Re: PETITION NO. 1600 – TRITEC Americas, LLC notice of election to waive exclusion from Connecticut Siting Council jurisdiction, pursuant to Connecticut General Statutes §16-50k(e), and petition for a declaratory ruling, pursuant to Connecticut General Statutes §4-176 and §16-50k, for the proposed construction, maintenance and operation of a 0.999-megawatt AC solar photovoltaic electric generating facility located at Parcel No. 30-2-74-40 Chamberlain Highway, Berlin, Connecticut, and associated electrical interconnection. **Petitioner Responses to Interrogatories from Council.**

**TRITEC Americas, LLC
Parcel No. 30-2-74-40
Chamberlain Highway, Berlin, Connecticut**

**Interrogatories
February 7, 2024**

Sheet Title:	Sheet #:
SITE LAYOUT PLAN	2.11

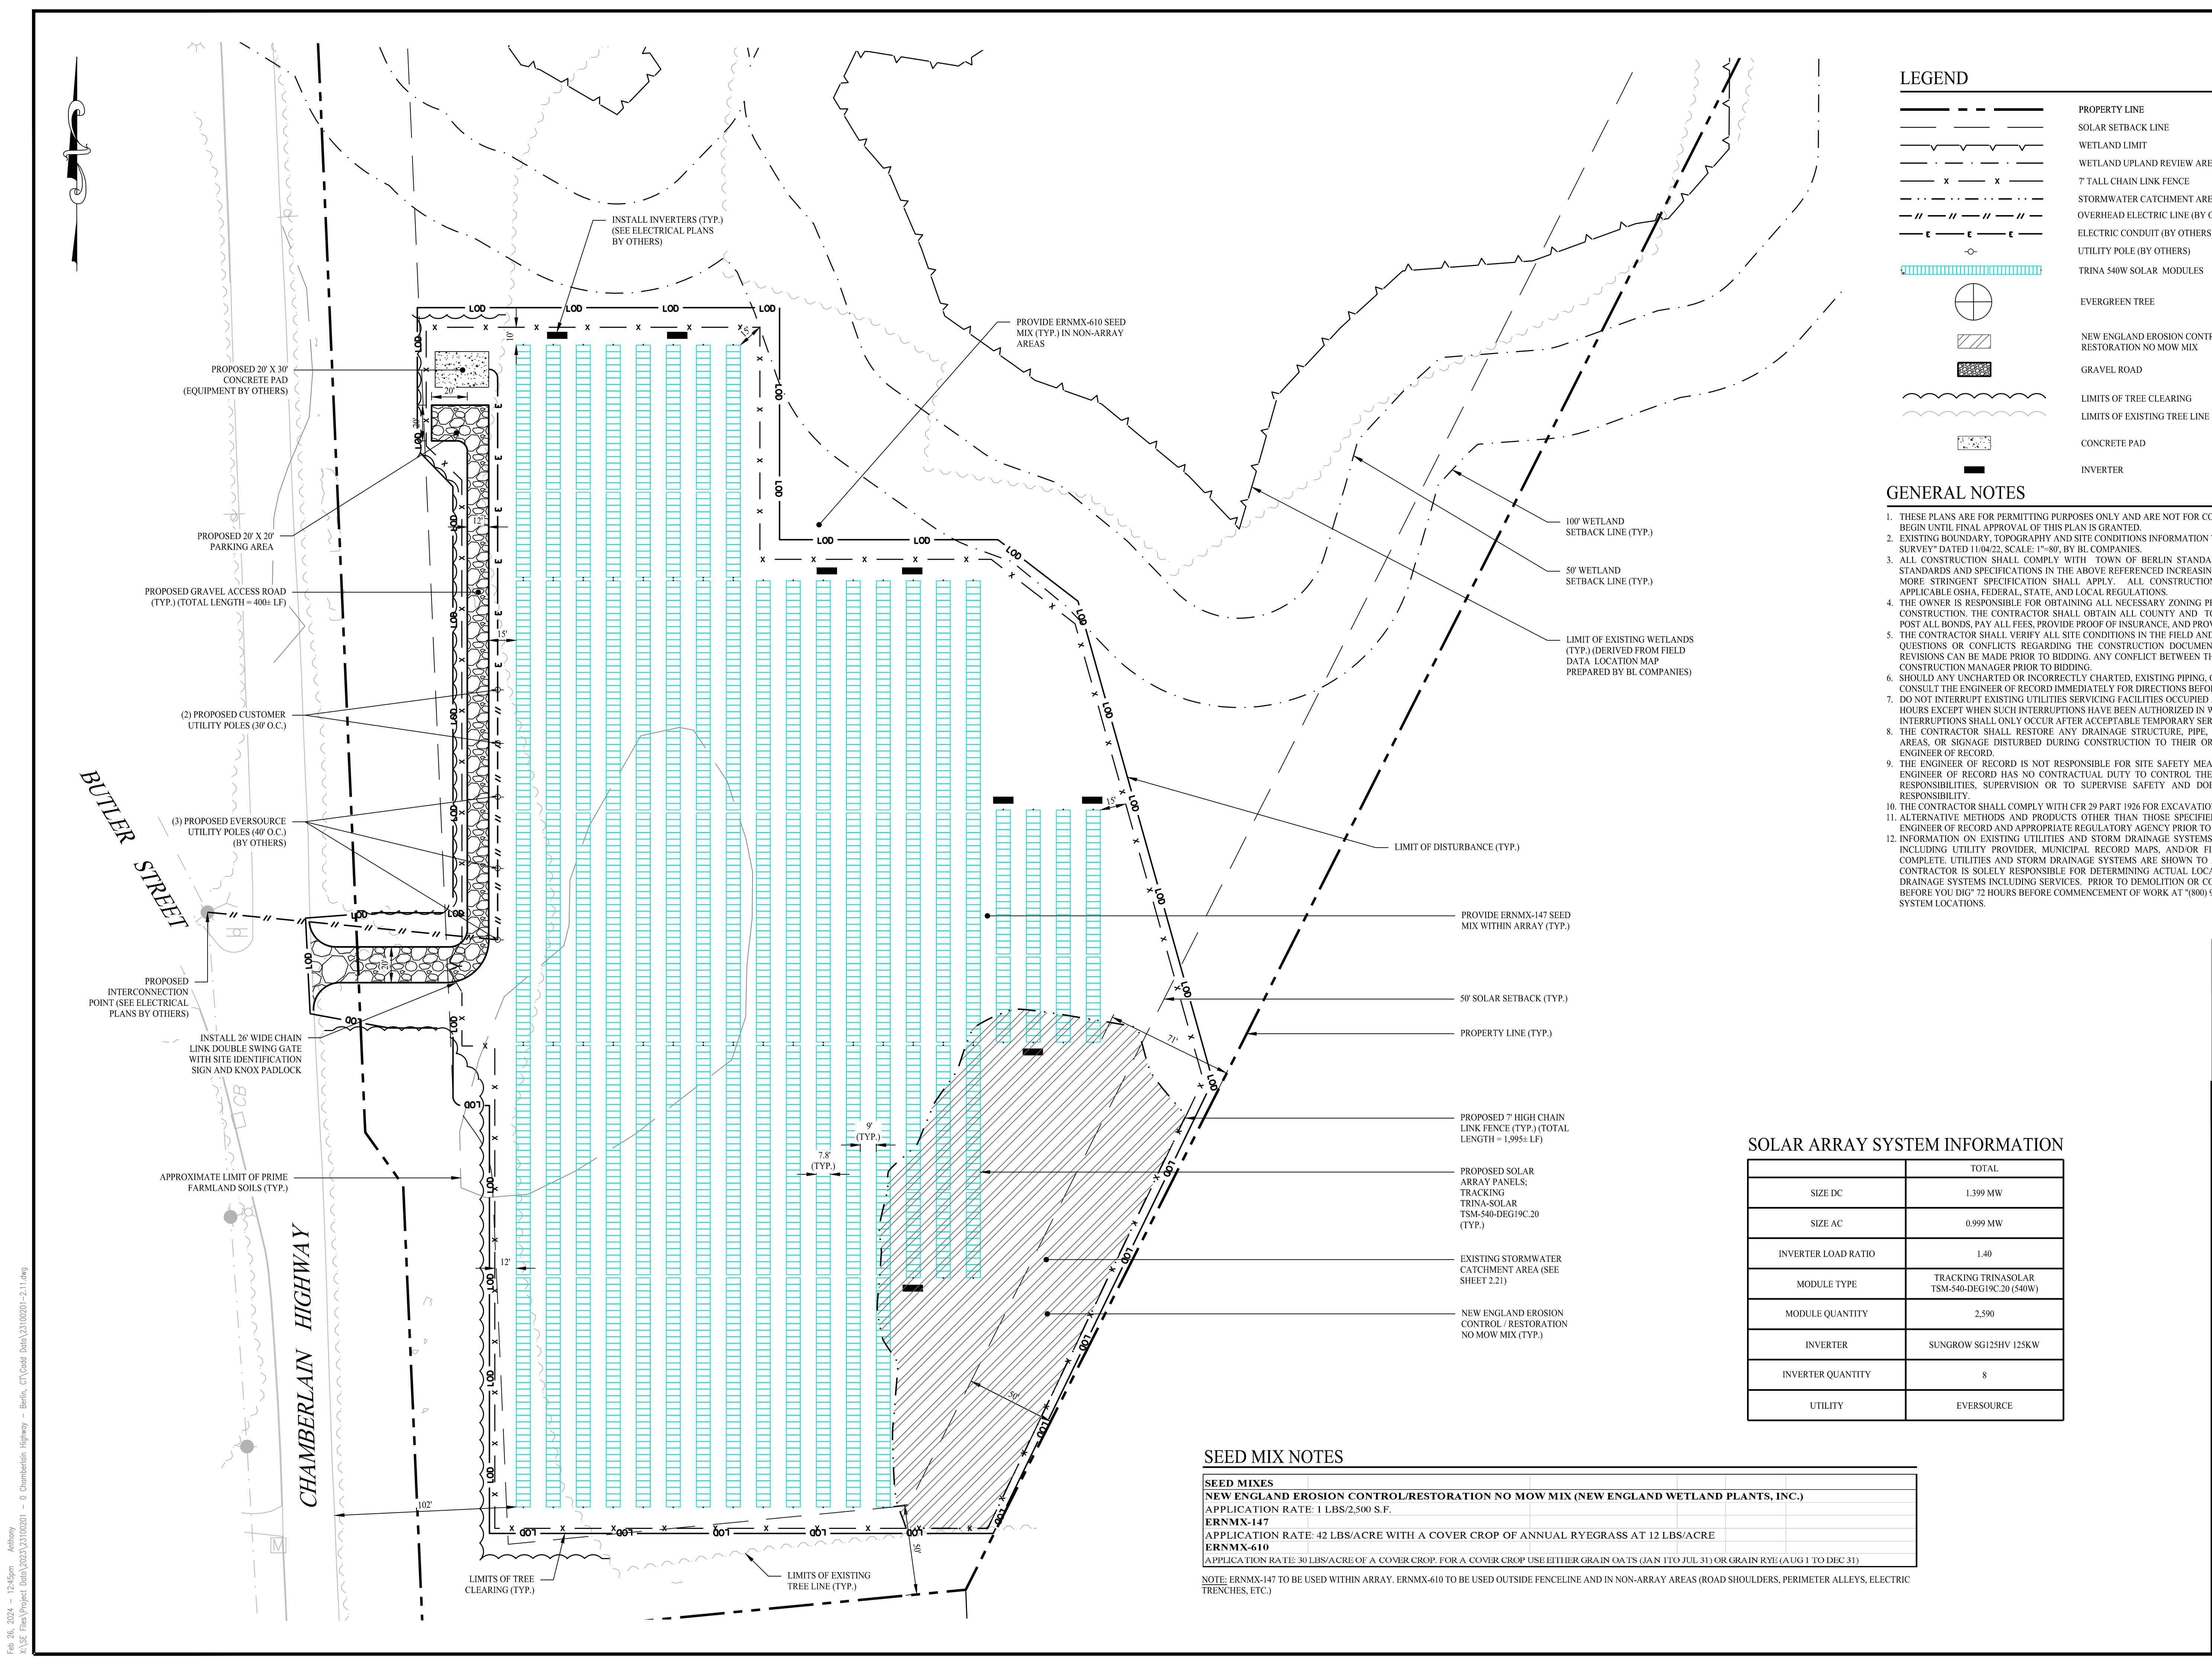
22. Referencing Petition Site Plan 2.11, what equipment would be installed on each utility pole? Can the number of poles be reduced by consolidating equipment?

23. Referencing Petition Site Plan 2.11, why do the utility poles need to be within 10 feet of each other? Can some or all the utility poles be located farther to the south of the access road entrance?

RESPONSE: The Site Plan 2.11 has been modified to provide 40-foot spacing between the (3) Eversource-owned utility poles and 30-foot spacing between the (2) customer-owned poles. The poles are placed along the proposed access drive. Ultimately Eversource will dictate the exact details of the interconnection as it pertains to quantity and spacing of poles, however the proposed alignment is based on recent projects of similar size. Enclosed, please see, "Site Layout Plan 2.11."

7' HIGH CHAIN LINK FENCE DETAIL

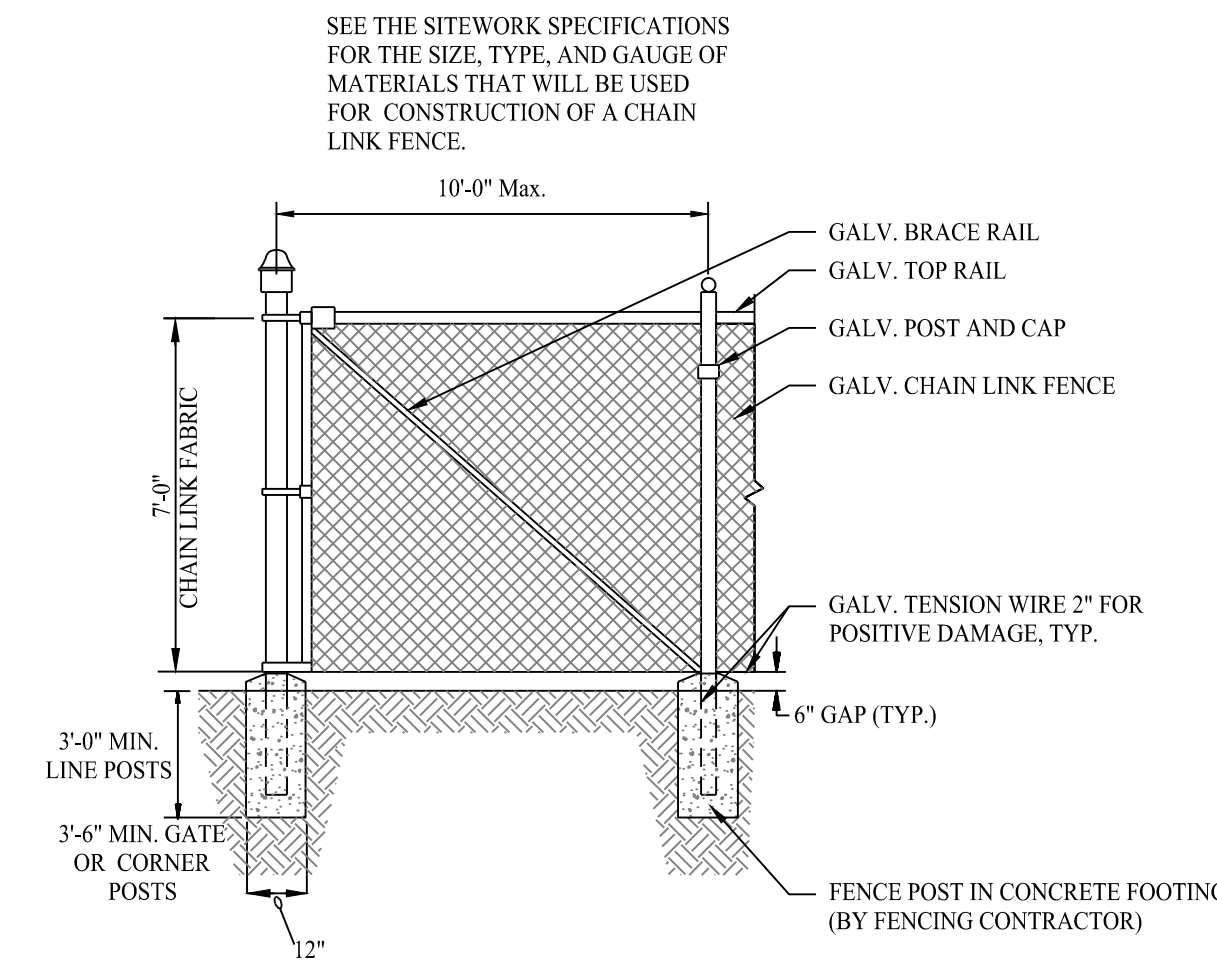
35. Referencing Petition Site Plan 3.01- Fence Detail, and Petition Exhibit F, p. 11, can the bottom of the perimeter fence fabric be raised to a height of six-inches above grade to allow for small wildlife movement?

RESPONSE: The 7' high chain link fence detail on Sheet 3.01 "Construction Details" has been modified to provide a 6" gap above grade. Enclosed, please see, "Construction Details 3.01."
